AMBLER BOROUGH PLANNING COMMISSION

- IV. NEW BUSINESS:**
 - 1. Review the 9 N. Maple Street Conditional Use proposing a 92 residential unit five story building with associated parking – Ambler Lakeview Development LP

Re: MCPC #21-0200-003
Plan Name: The Ambler Conditional Use
2 lots comprising 2.67 acres
Situate: 9 North Maple Avenue, between Butler Avenue and Ambler Avenue
Ambler Borough

Reference: Preliminary/Final Land Development
Residential Apartment Building - Ambler Lakeview Development, L.P.
9 N. Maple Avenue, Ambler Borough and 5 N. Maple, Upper Dublin Township
Tax Parcel #01-00-02938-40-9; Tax Parcel #01-00-02938-00-4

Attachment B: Reduced Copy of Applicant's Proposed Site Plan

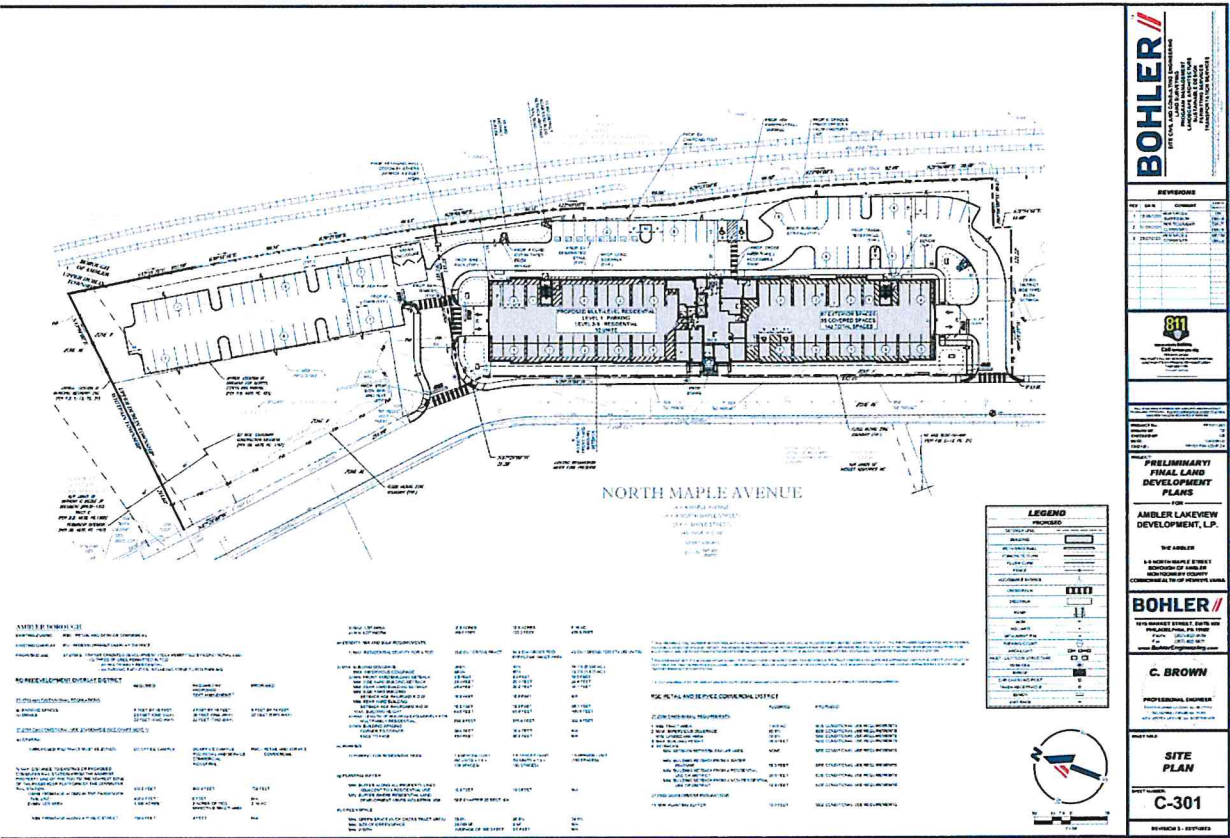
- A. Maple Avenue Property Frontages. The plan set indicates that the applicant proposes to add sidewalk along the Maple Avenue frontage of the building. We strongly recommend that the applicant be required to complete the sidewalk along all frontages of both parcels with Maple Avenue. The portion that is not proposed to have sidewalks is within Upper Dublin Township. Upper Dublin Township requires sidewalks of a minimum of five feet in width along all streets per §212-18 of the Subdivision and Land Development Ordinance. The applicant will likely need to seek a waiver from Upper Dublin from providing sidewalks along this frontage.
